November 17, 2014

RFBNO.314001 - ADDENDUM NO. 1

BUILDINGS C & D NEIGHBORHOODS REMODEL - REBID

BADGER PRAIRIE HEALTH CARE CENTER
 Buildings C & D Neighborhoods Remodel - Rebid
 Bid No. 314001

1 PARTIAL FIRST FLOOR PLAN - ELECTRICAL
E101 1/8"=1'-0" BUILDING D - ALTERNATE BID 1

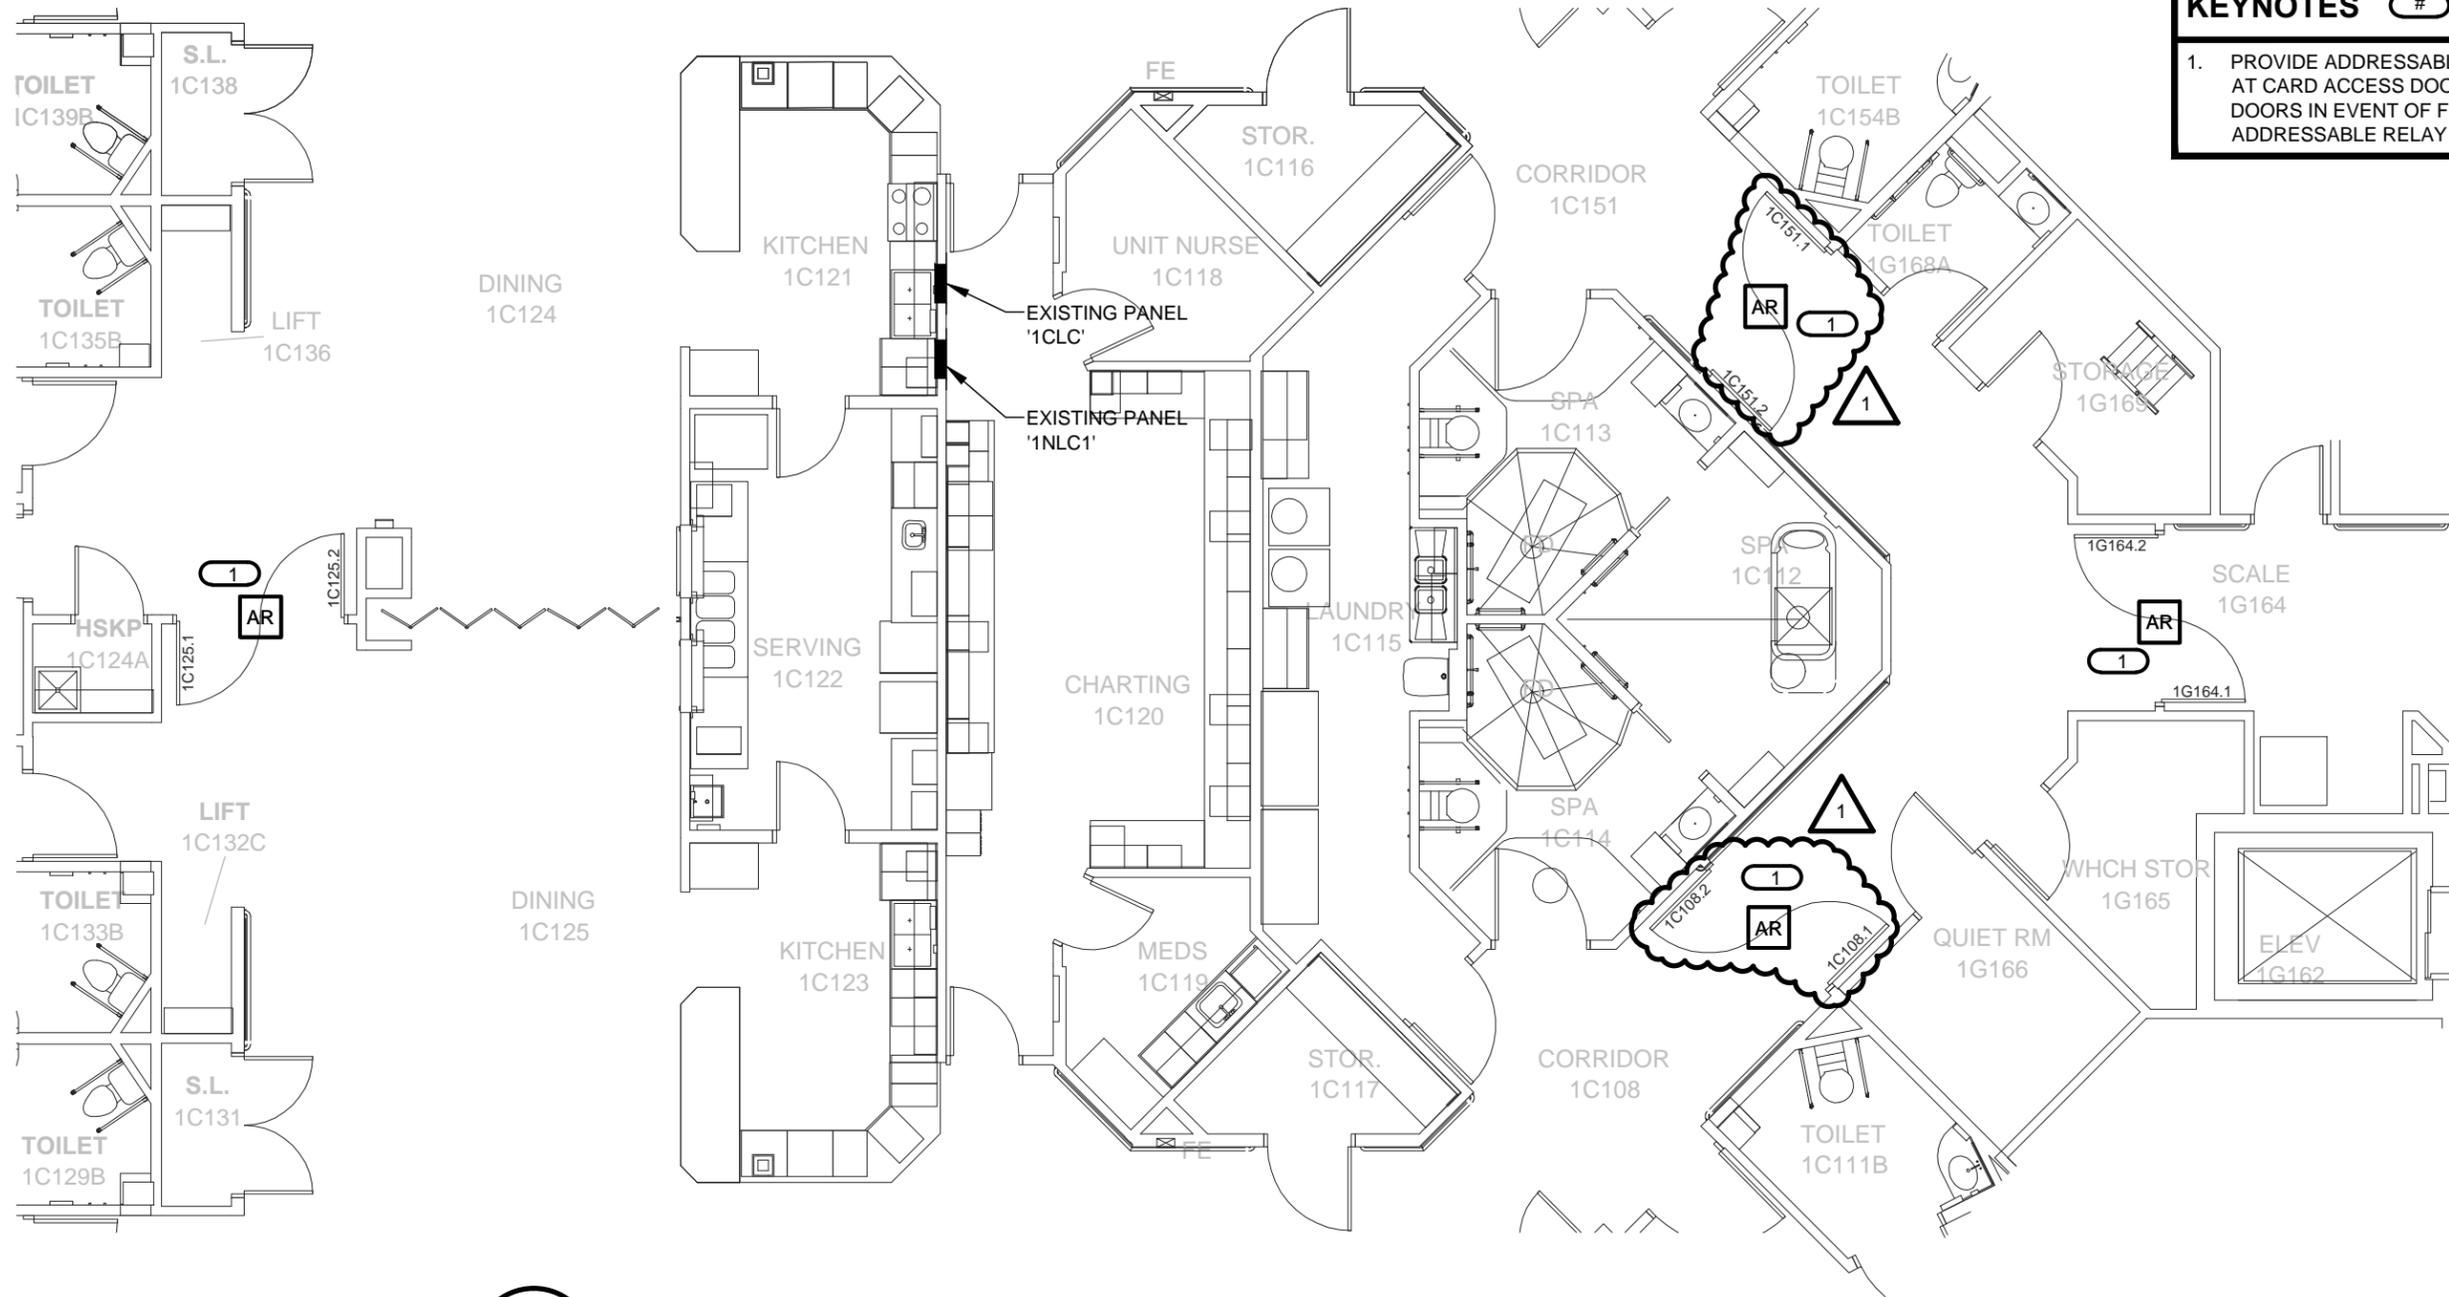
Adds door number 1D101.

1 PARTIAL FIRST FLOOR PLAN - ELECTRICAL
 E102 1/8"=1'-0" BUILDING C - ALTERNATE BID 2

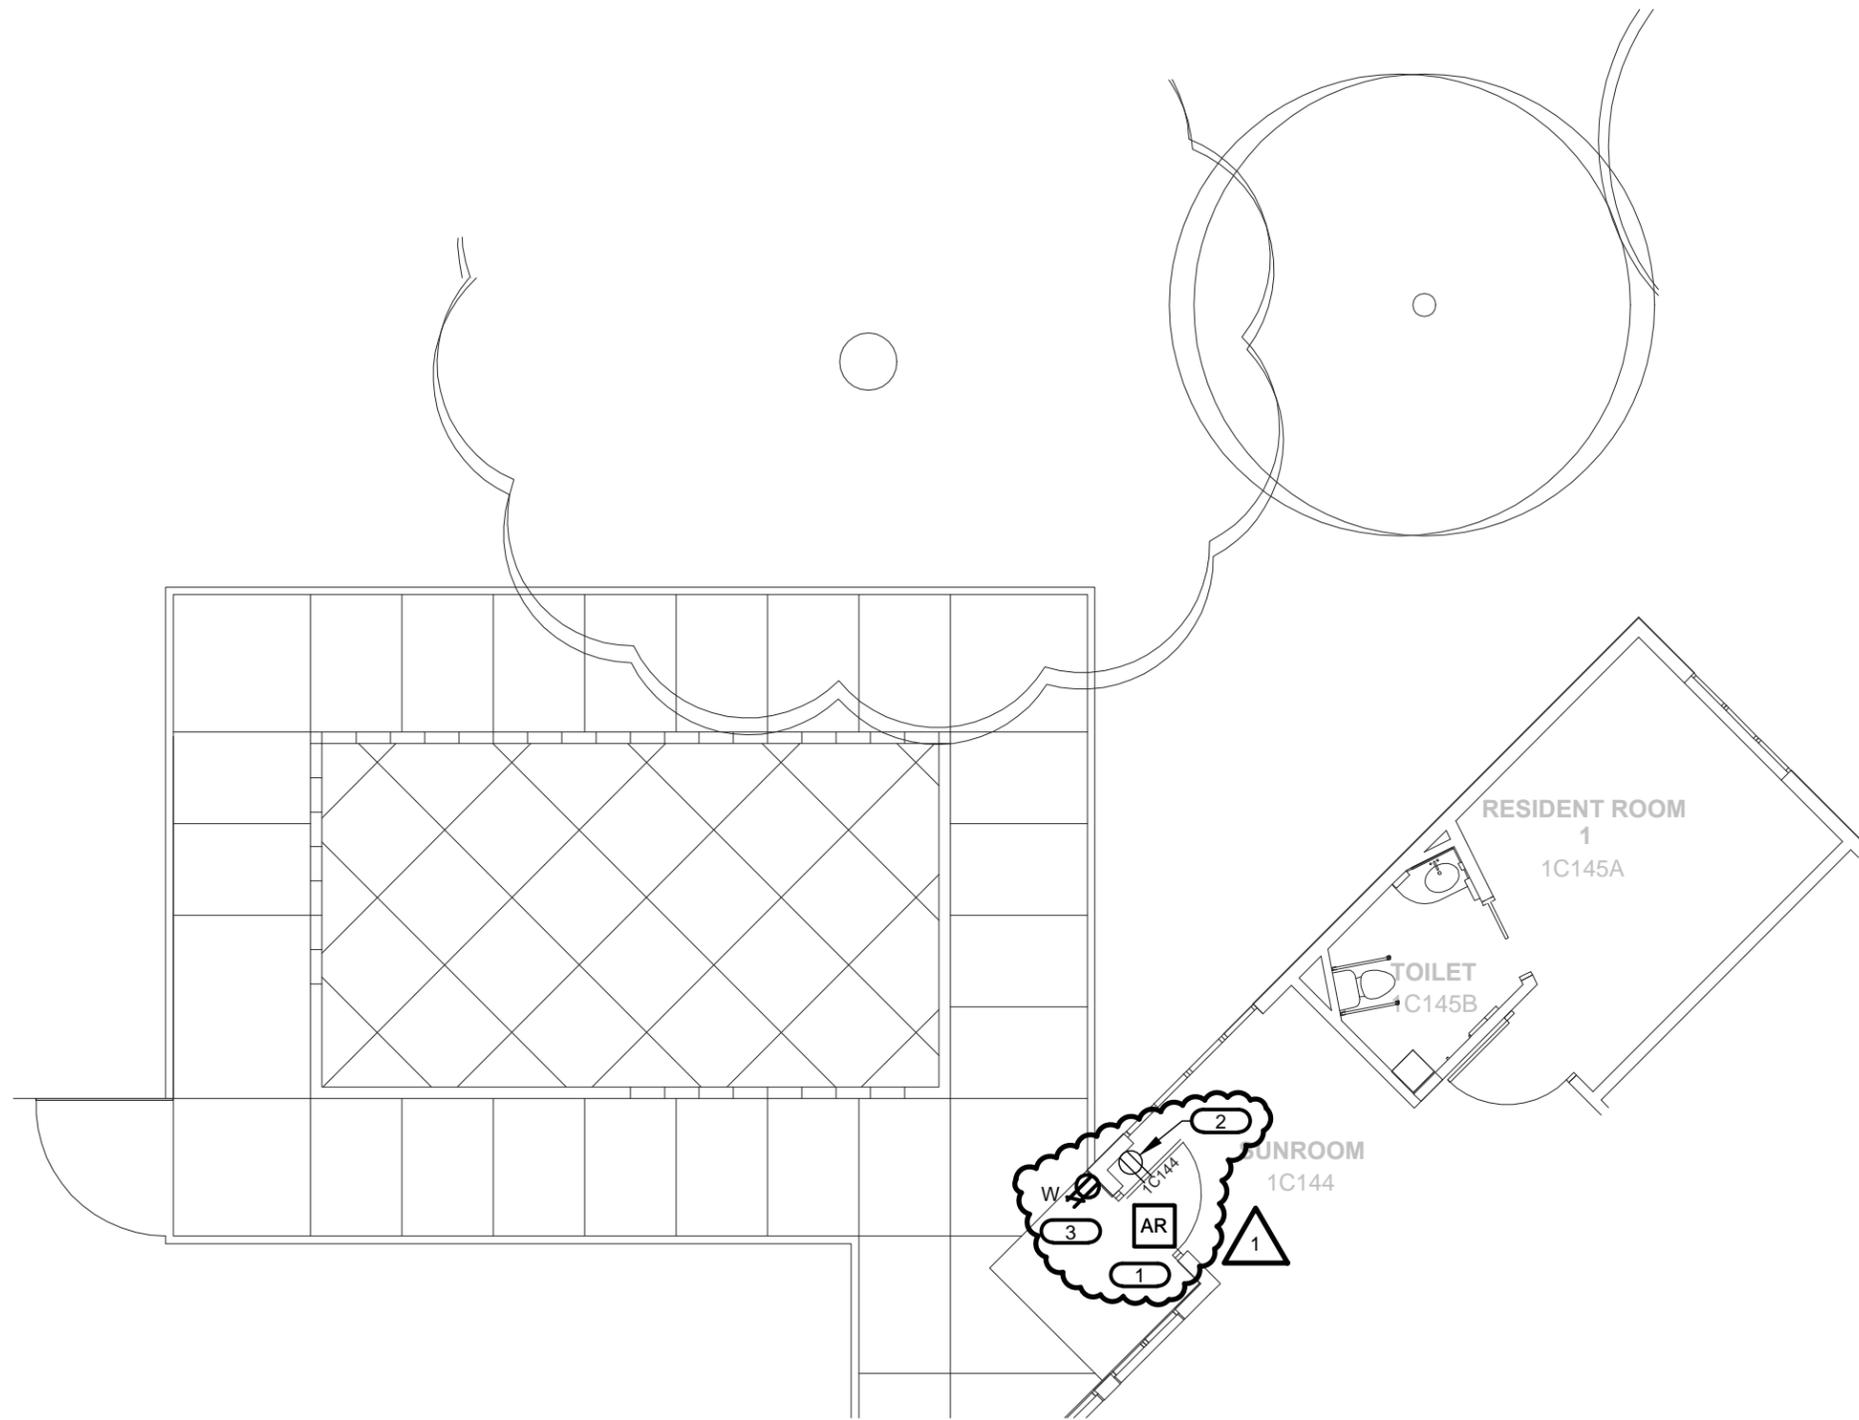
Revises door 1C108.2 to read “1C108.1”.

Revises door 1C108.3 to read “1C108.2”.

Revises door 1C151.3 to read “1C151.1”.

Revises door 1C151.4 to read “1C151.2”.

1 PARTIAL FIRST FLOOR PLAN - ELECTRICAL
E103 1/8"=1'-0" BUILDING C - ALTERNATE BID 3

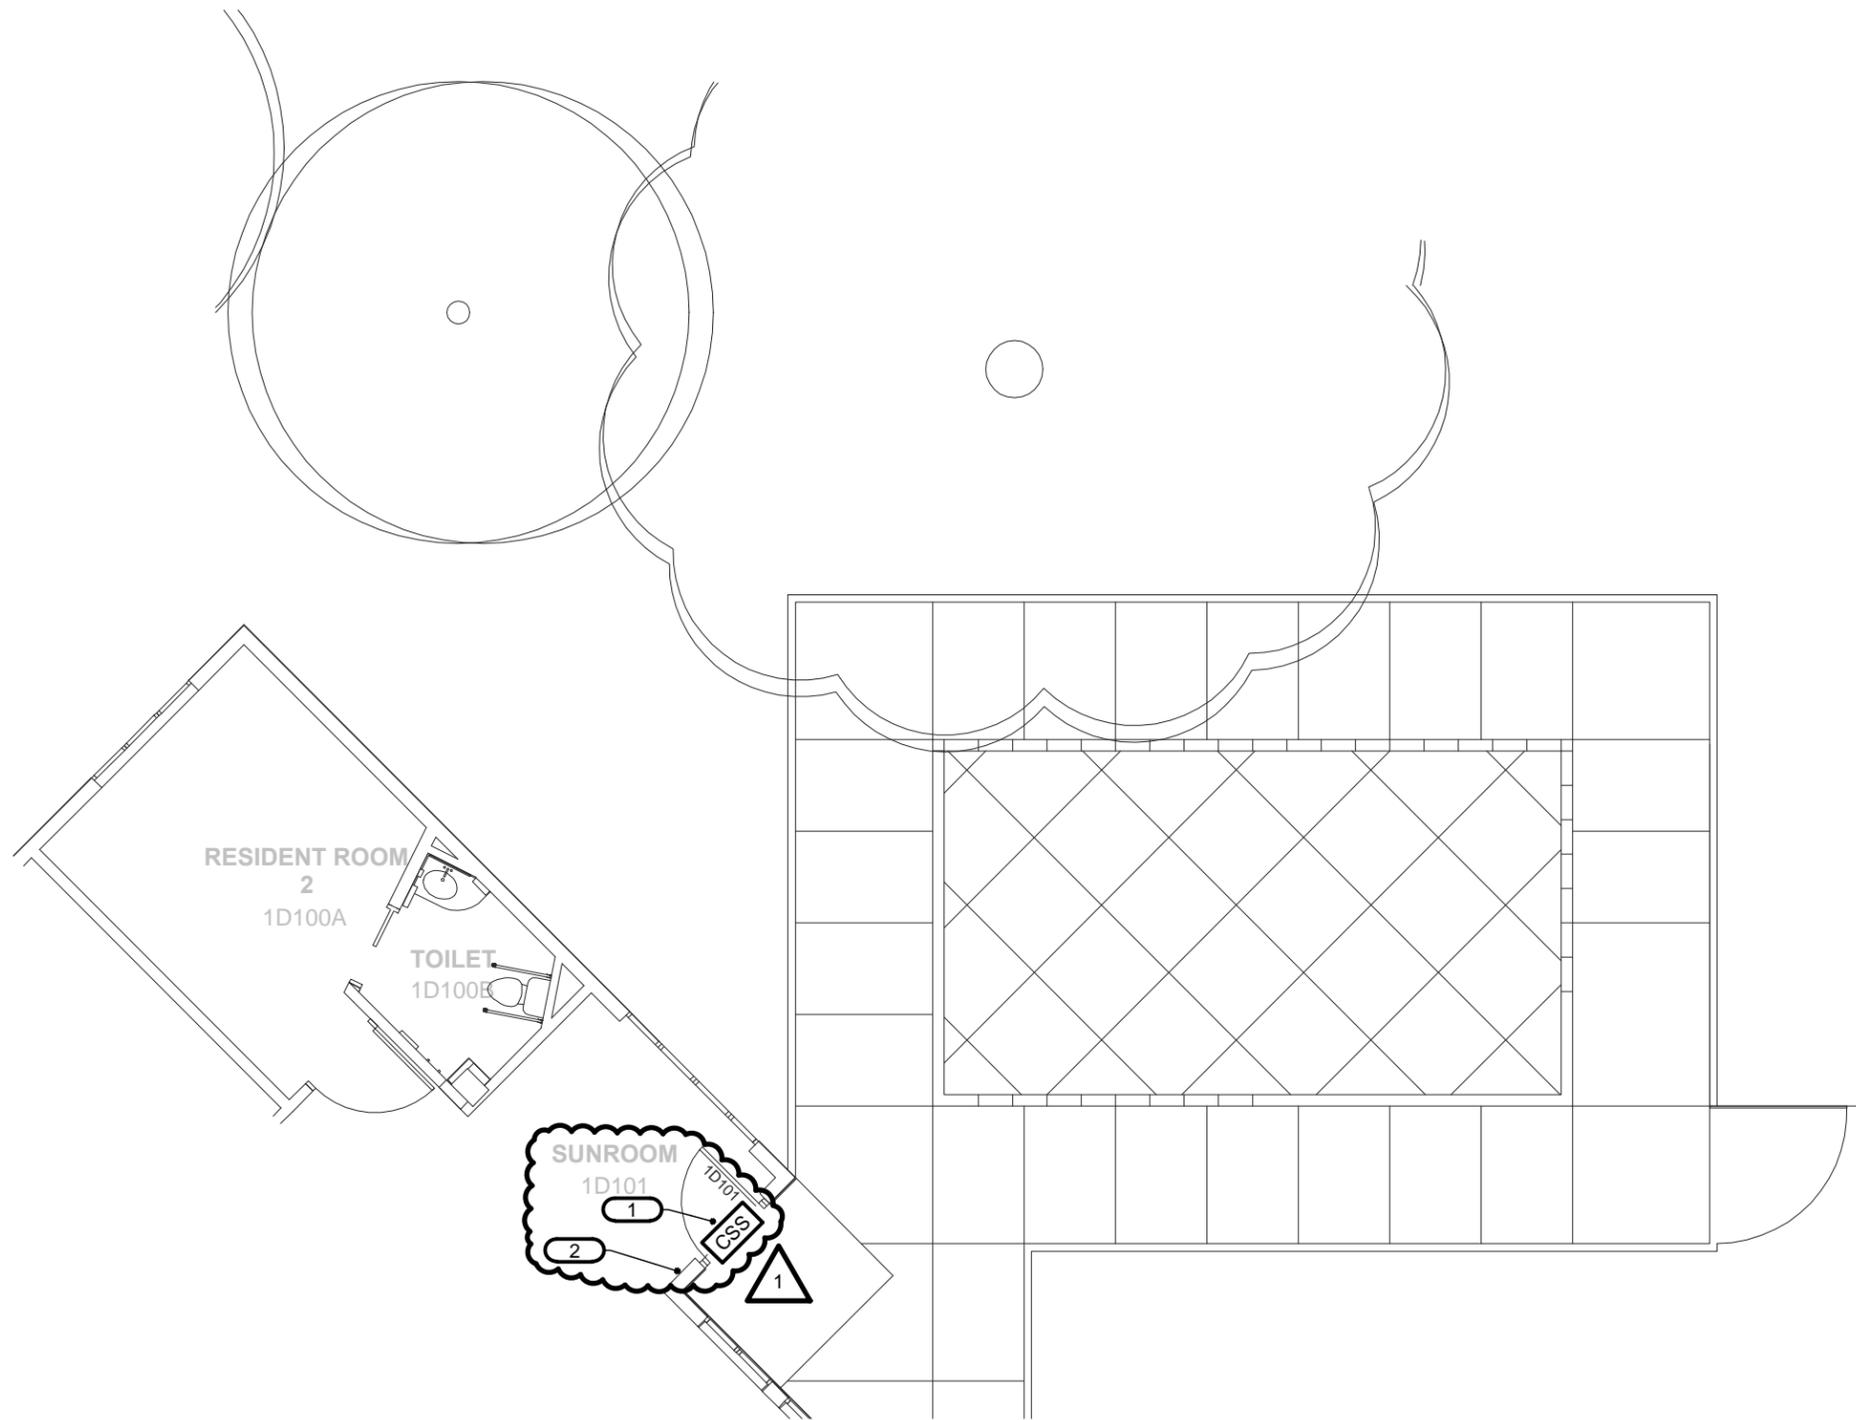
Adds door number 1C144.
